**Re: Planning & Development Committee Meeting - April 24th, 2023
Agenda Item No. 7.1
Amendment to the Credit Valley Secondary Plan (Springbrook Tertiary Plan)
Cal Markell Development Inc.
1724-1730 Queen St. W.
City of Brampton, Region of Peel**

ATTACHMENT 1
DRAFT SCHEDULE – APRIL 24, 2023

SCHEDULE SP45(b) Springbrook Settlement Area Tertiary Plan

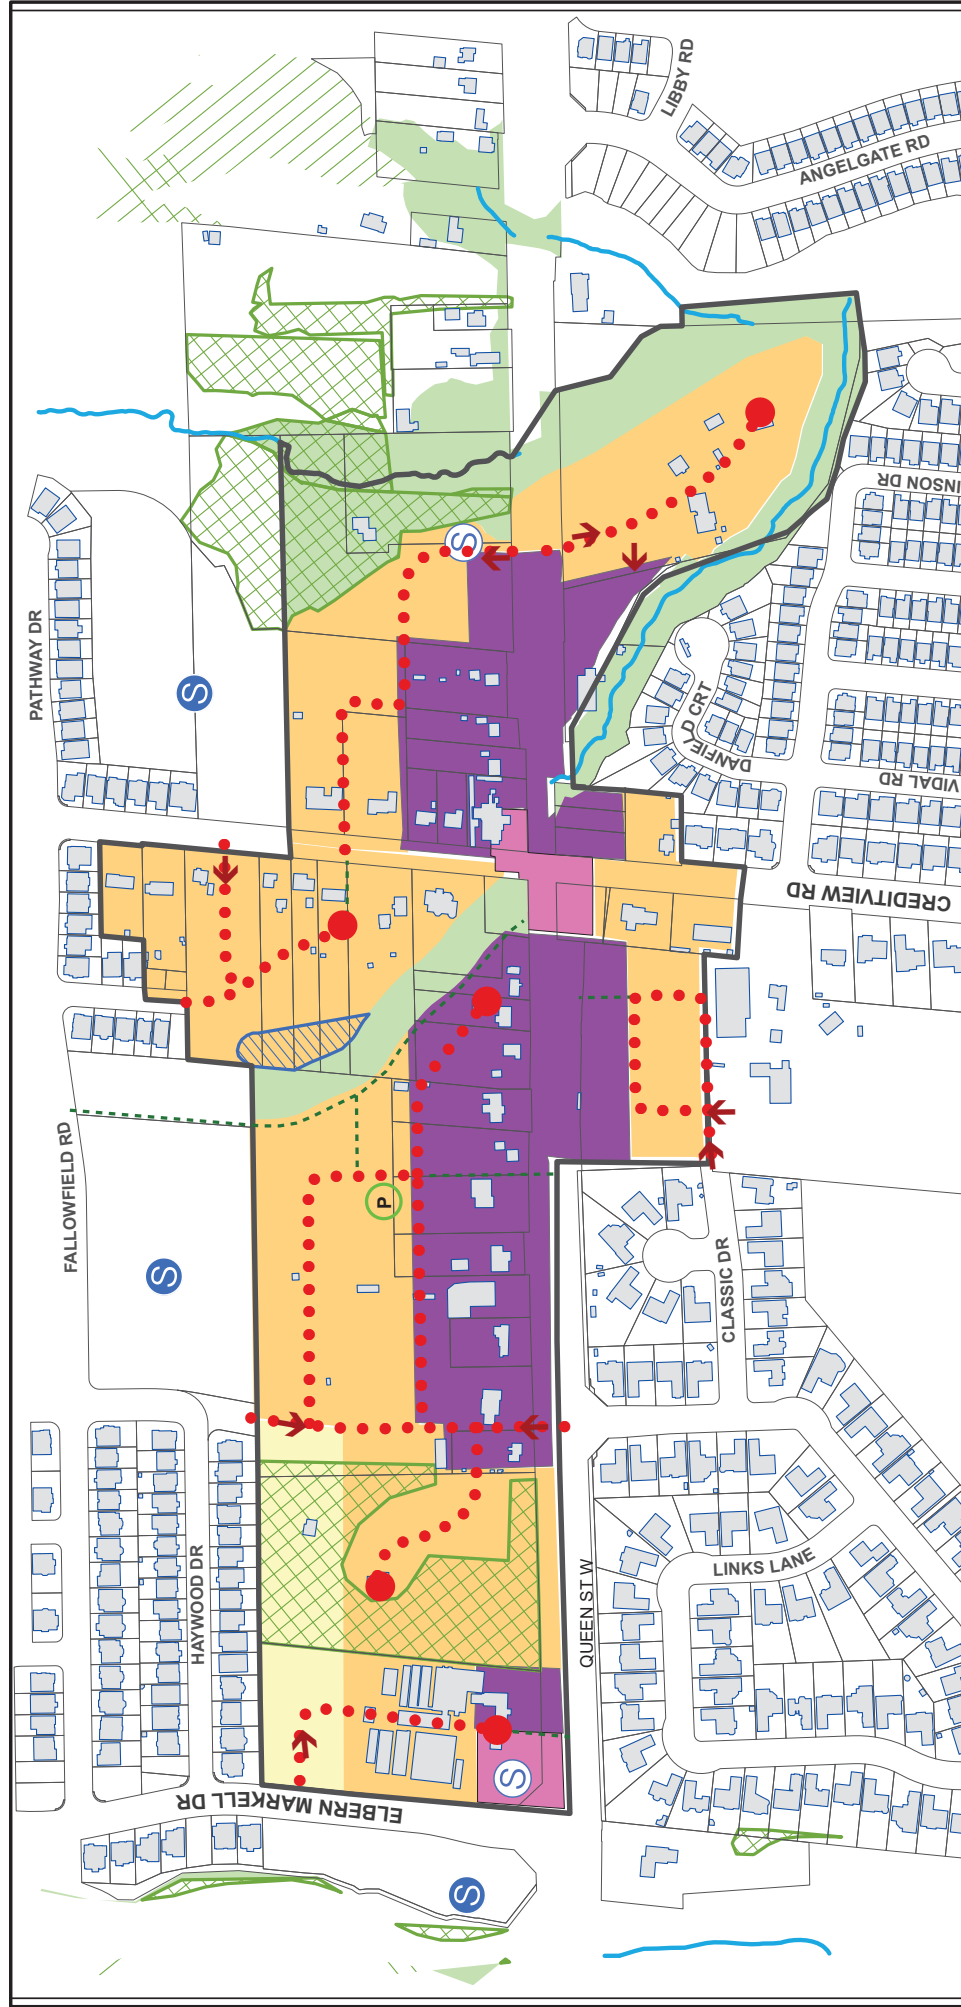
Upon review of the proposed Tertiary Plan, Schedule SP45(b) does not reflect the applications in process for the subject lands, as it proposes to designate the subject lands a combination of “Low Density Residential” (permitting single detached, semi-detached, and townhouse dwellings), Low-Medium Density Residential” (permitting single detached, semi-detached, and townhouse dwellings), Medium Density Residential” (permitting up to 12-storey apartment building forms), and “Mixed-Use Medium-High Density Residential” (permitting up to 14-storey apartment building forms with required ground level commercial). A stormwater management pond (subject to future study) is conceptually shown at the southwest corner of the site closest to the intersection of Queen St. W. and Elbern Markell, and a “Road” is identified internal to the site.

In this case, it is requested that Schedule SP45(b) is revised to remove the “Proposed Stormwater Management Pond (Subject to Further Study)” indication from the subject lands.

It is requested that Schedule SP45(b) is revised to remove the “Conceptual Road” linework from the subject lands.

Considering the above, it is requested that the lands be designated a combination of “Medium Density Residential” for the north portion of the site with a maximum height of three-and-a-half (3.5) storeys in a stacked townhouse form, and “Mixed Use Medium-High Density Residential” (with commercial uses permitted but not required) for the south portion with a maximum height of eighteen (18) storeys and be subject to the application of a 45 degree angular plane from the existing low-density residential uses to the north.
